PROPOSED IMPROVEMENT
BRIDGE PROJECT
TOWN OF ROCKINGHAM
COUNTY OF WINDHAM
VT 121 (CL 2, TH 1) RURAL MAJOR COLLECTOR
BRIDGE NO. 11R

PROJECT NAME : ROCKINGHAM
PROJECT NUMBER : BRF 0126(12)

Vermont Agency of Transportation
RECEIVED
ON: December 29, 2014
and Checked for
CONFORMANCE
BY: TAS DATE: 01/20/2015

DIAPHRAGM "D1" PLAN
(27) DIAPHRAGM D1 REQ'D

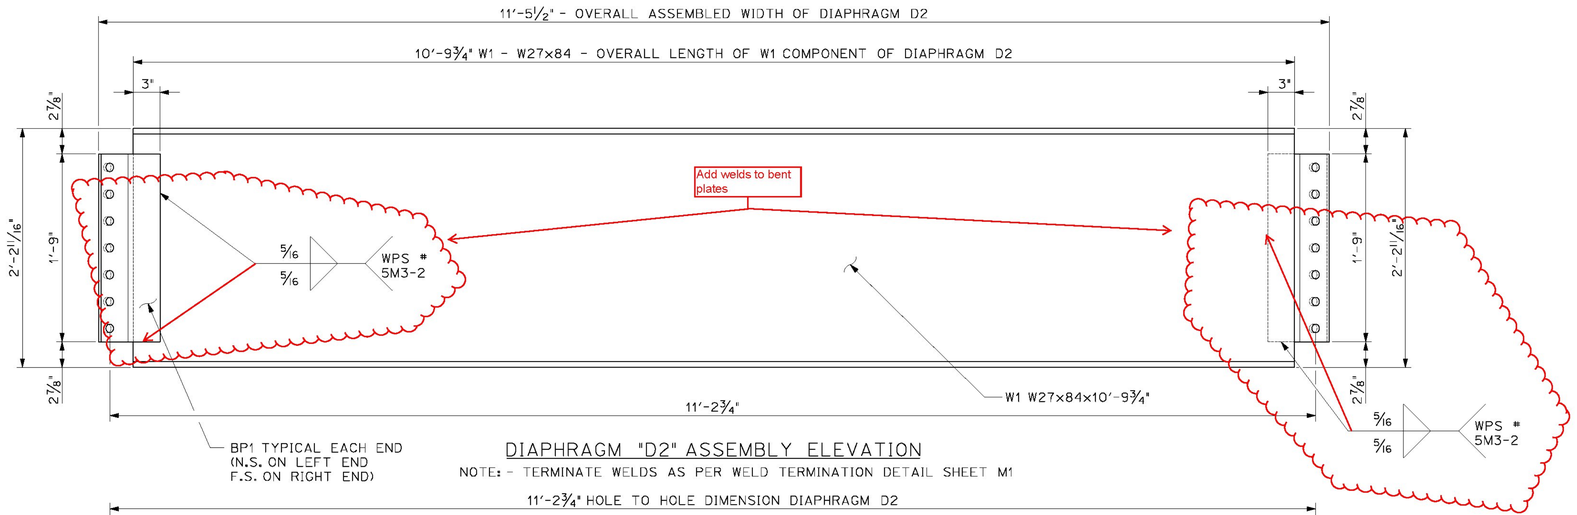
The cope doesnt match SD-602.00. Per that detail it should be 1" x 3" (typ)
